TISDALE WEIR REHABILITATION AND FISH PASSAGE PROJECT

Final Environmental Impact Report

Prepared for
California Department of Water Resources

August 2021

Figure 21
TUFLOW Model – Change in Average Depth by Parcel (Dry Days)
Tisdale and Sutter Bypass (Below Normal WYs), Project Conditions

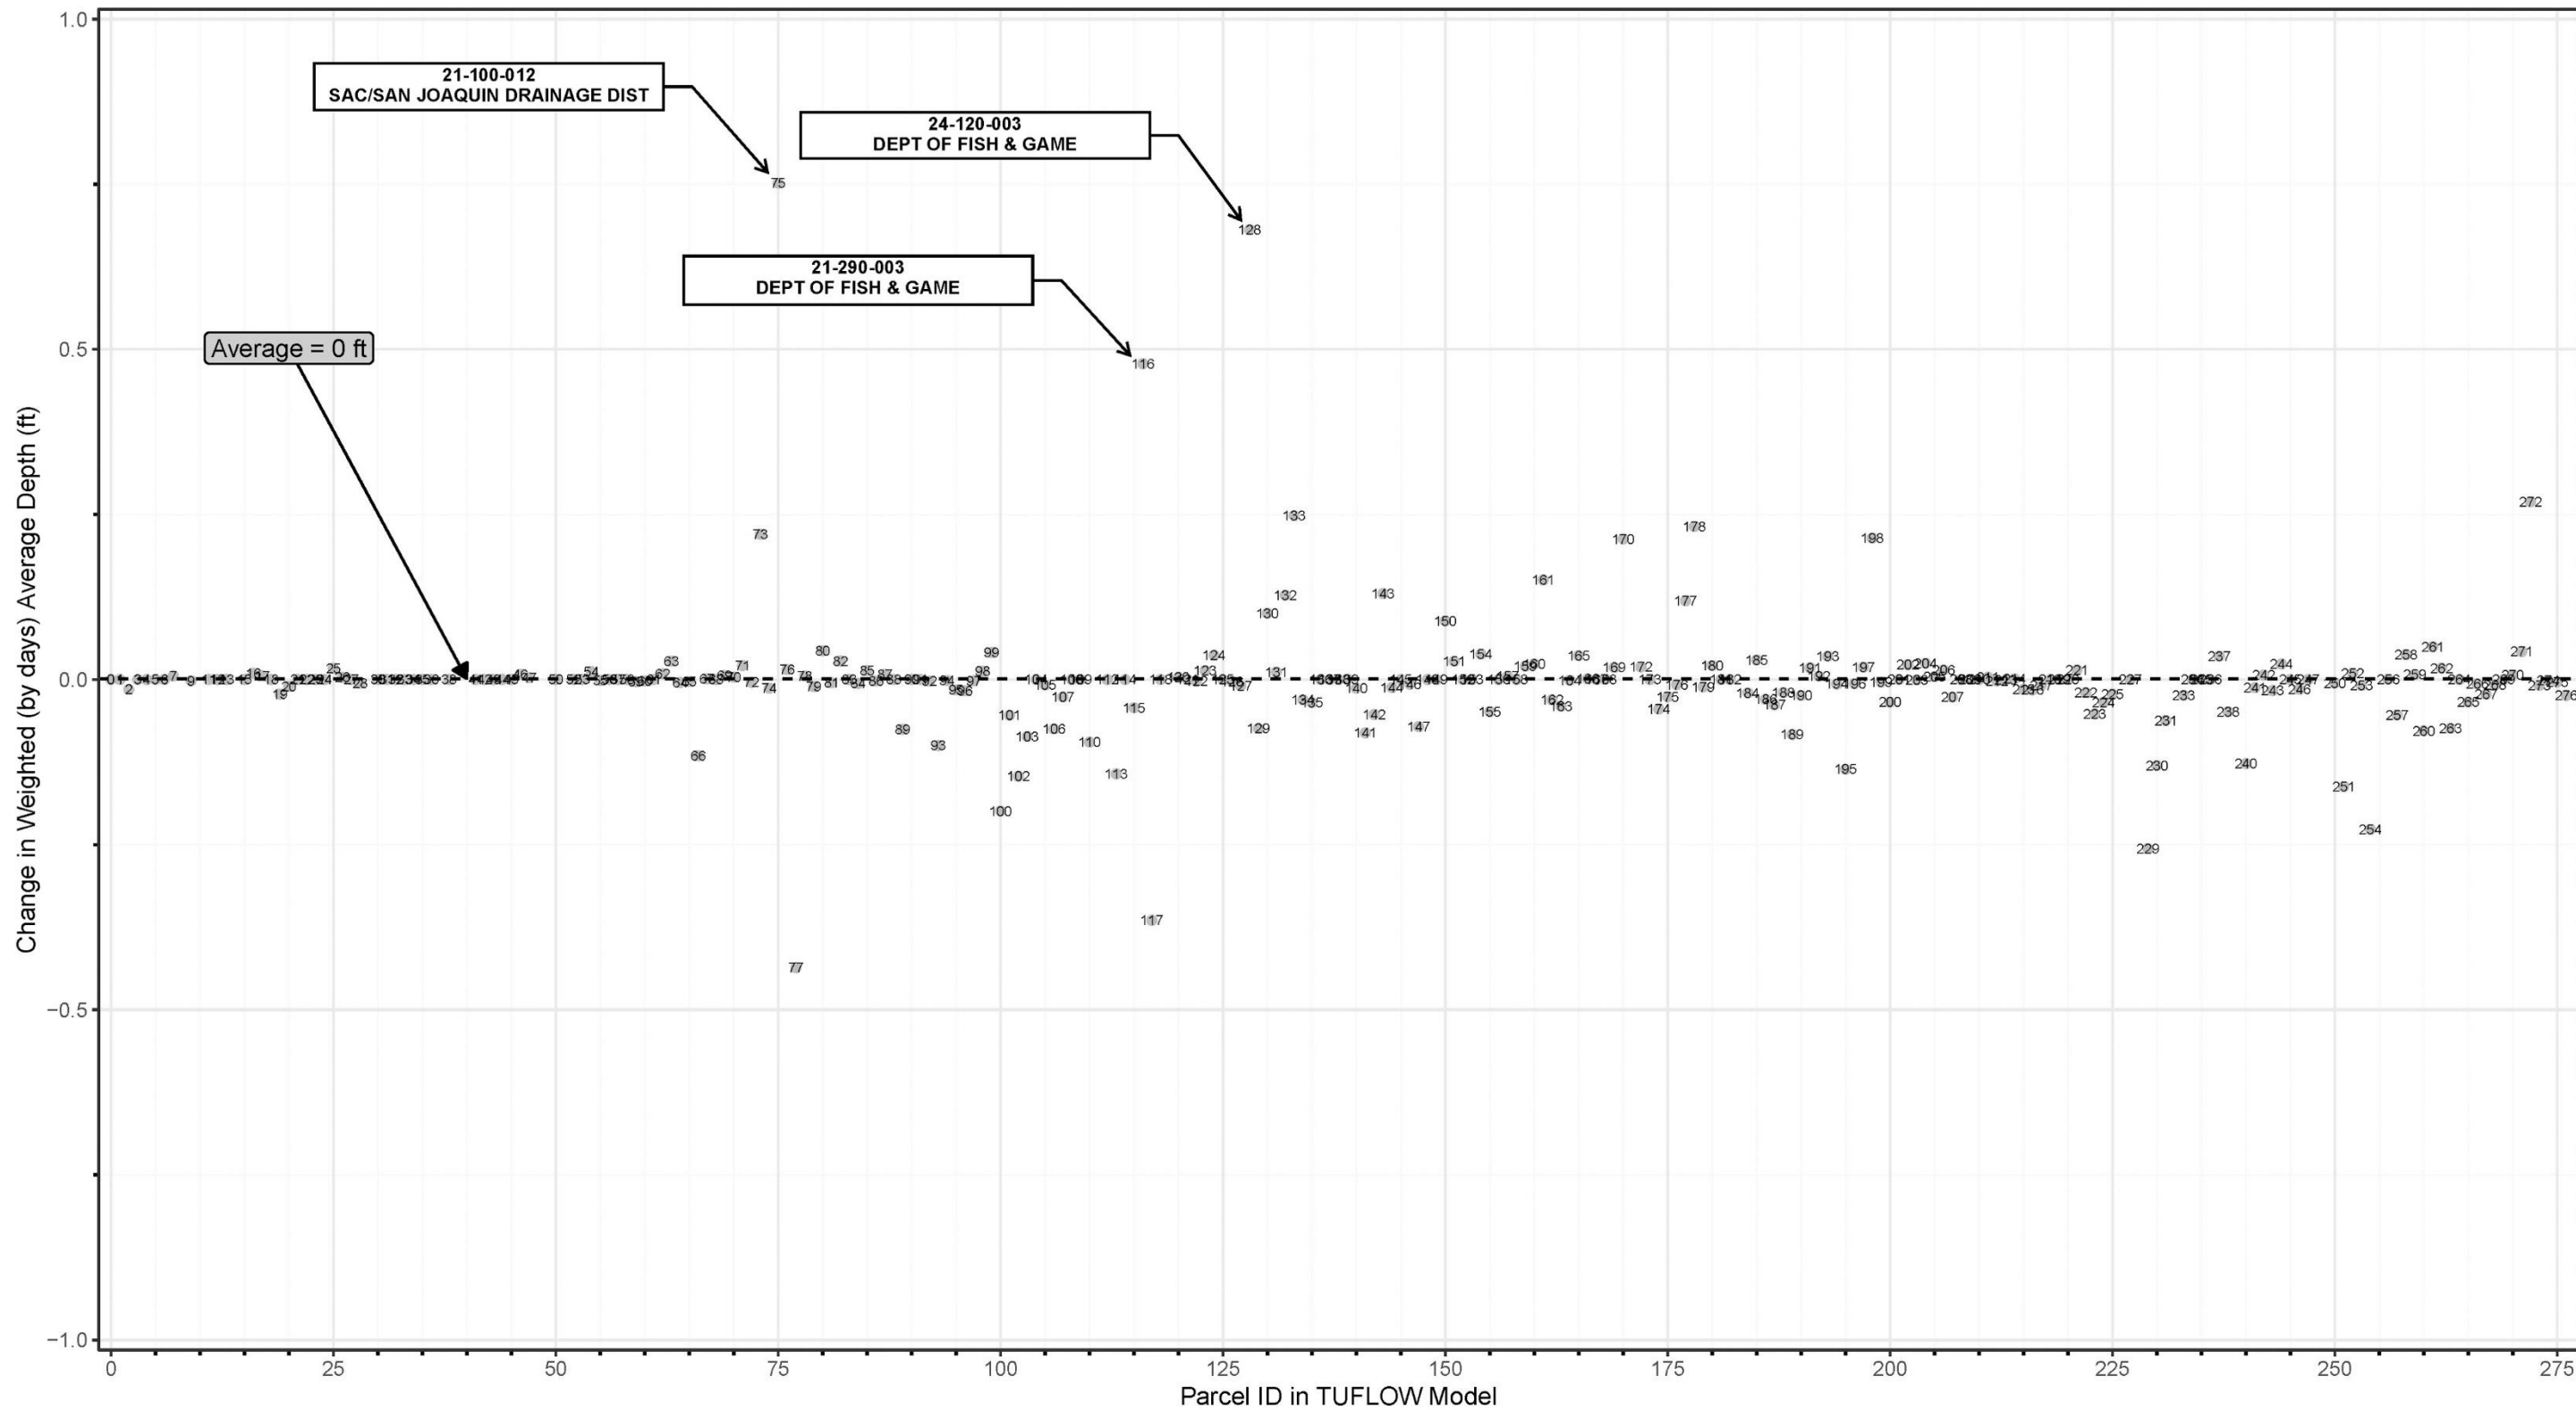
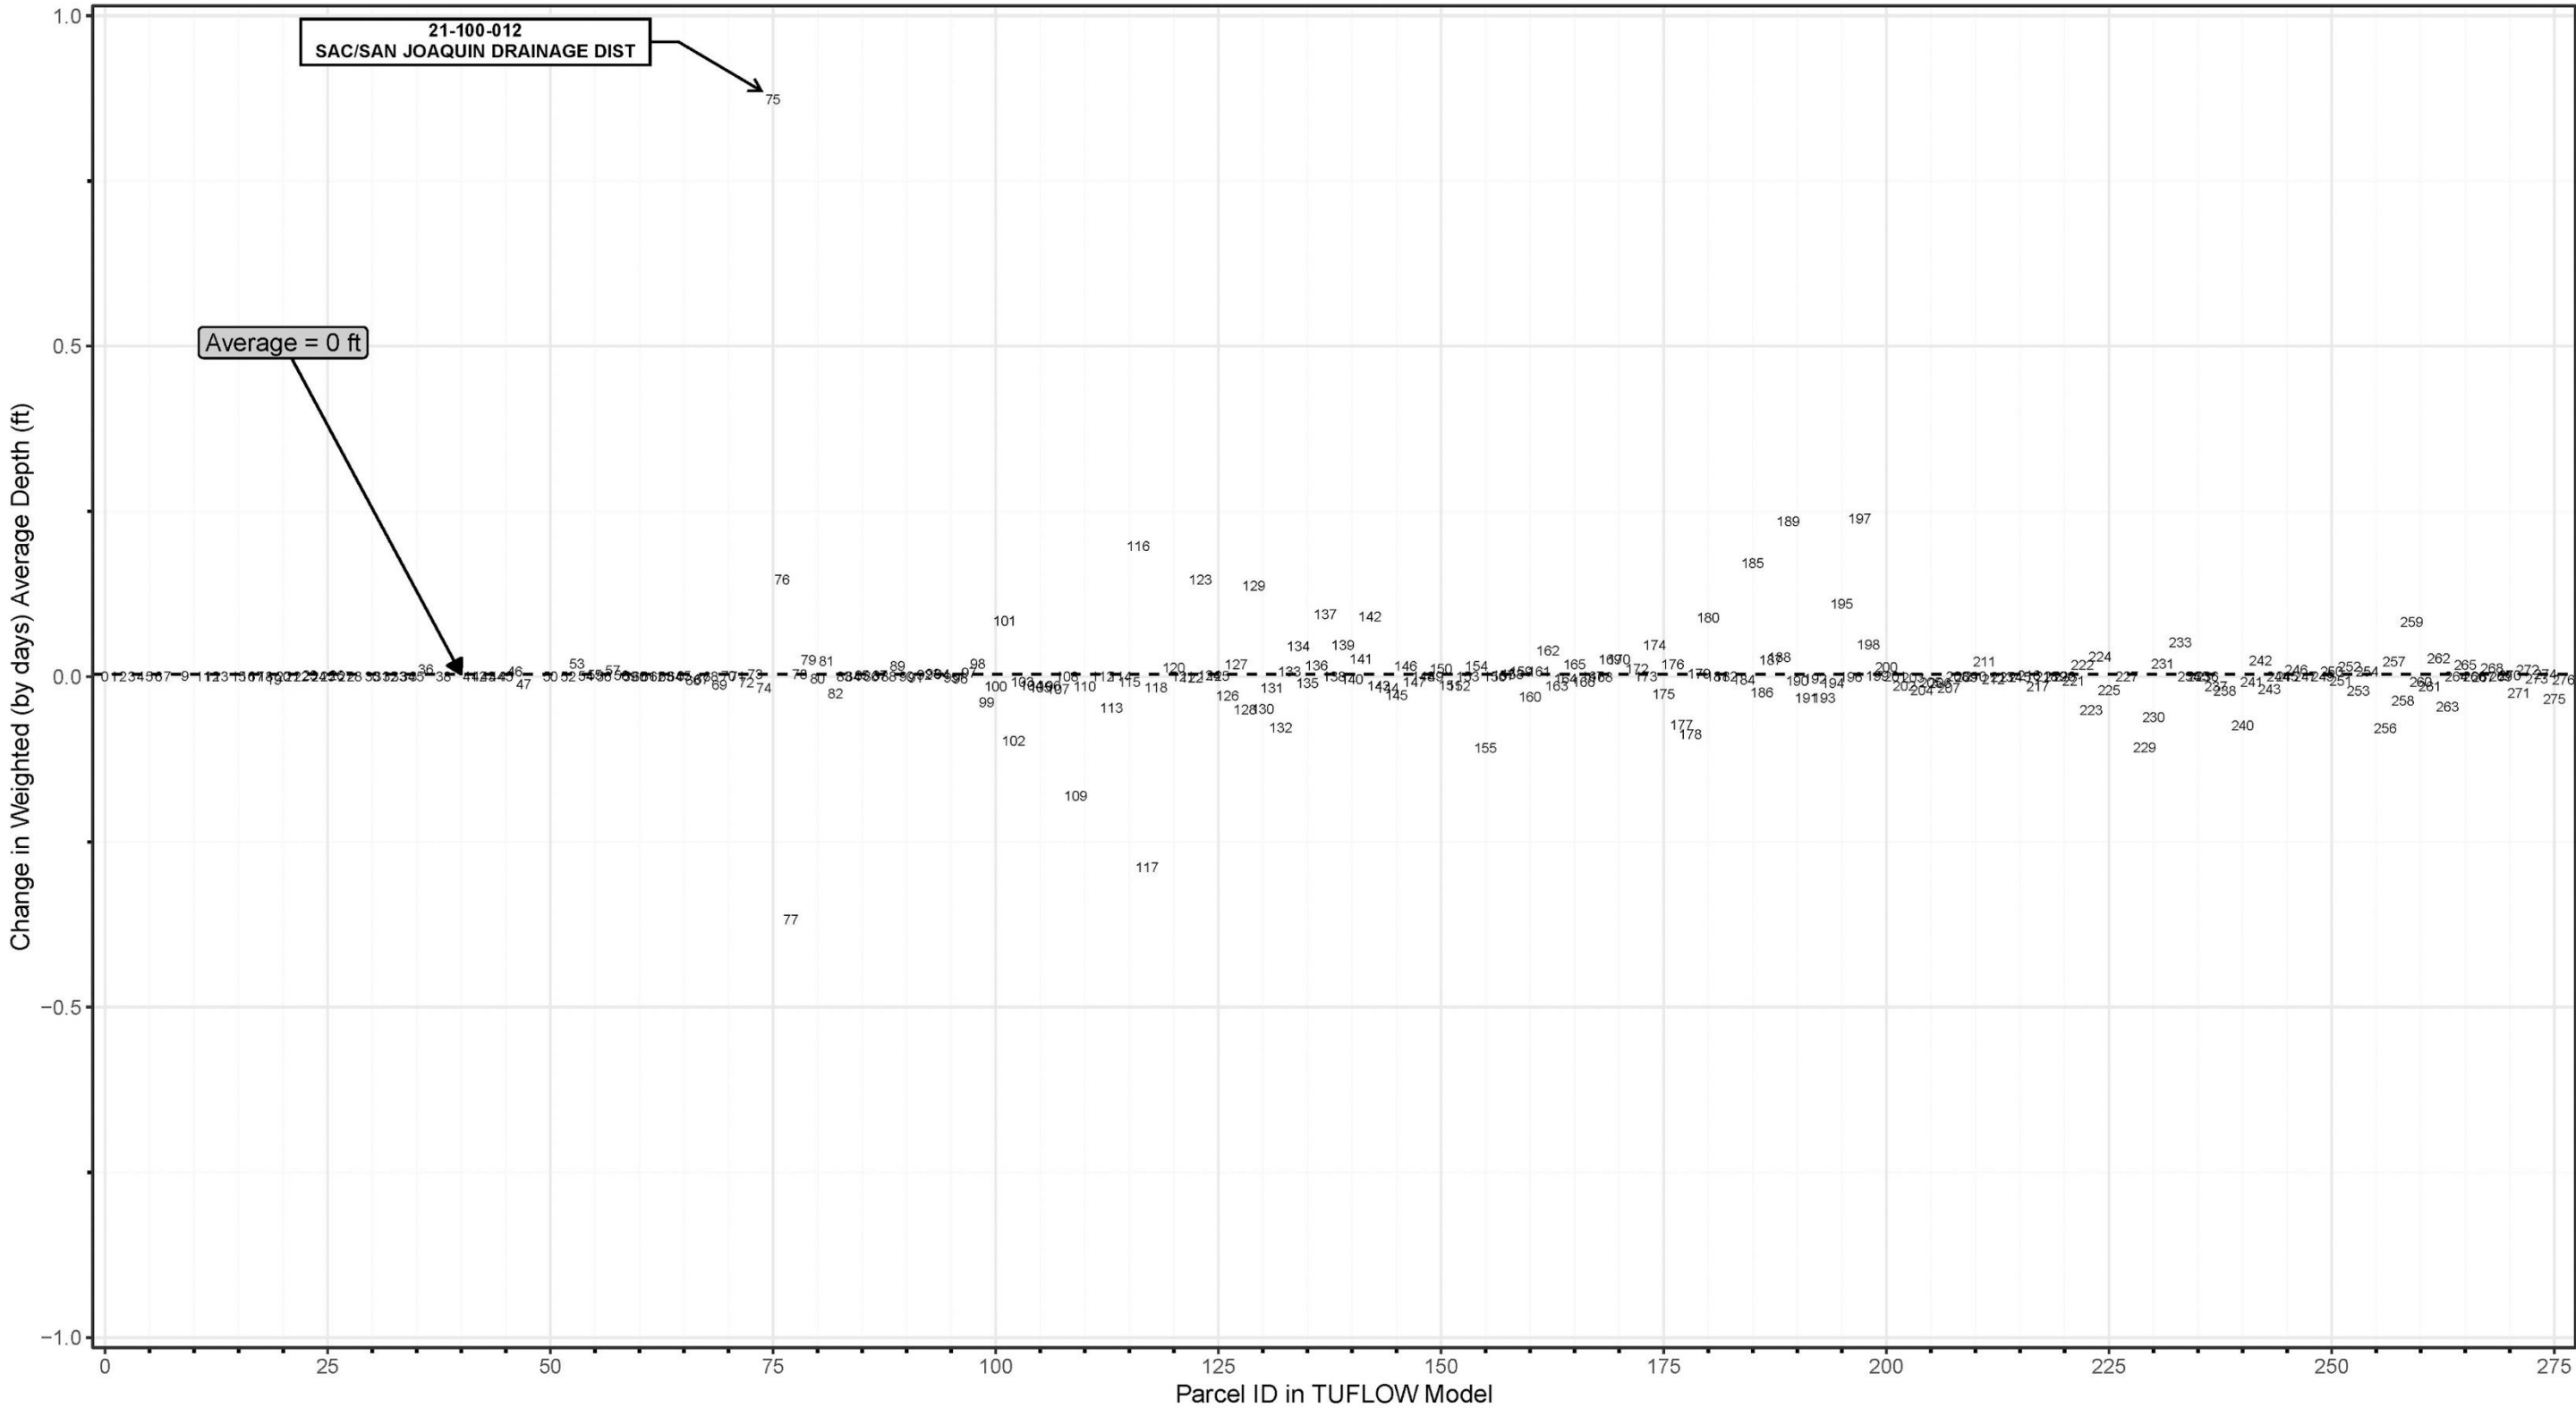
Figures 13 through 24 in Attachment E of this FEIR present the average changes in water depth, by water year type, for each parcel in the Sutter Bypass and, as shown, the predicted changes in water depth are very minor. As evident in Figures 13 through 24, the predicted increases in depth for wet days and dry days that are greater than approximately 0.5 feet are for parcels that belong to the Sacramento/San Joaquin Drainage District or the California Department of Fish and Wildlife (CDFW). In addition, Attachment F of this FEIR provides the change in the number of wet days for the waterfowl season for all water years and parcels in the Sutter Bypass.
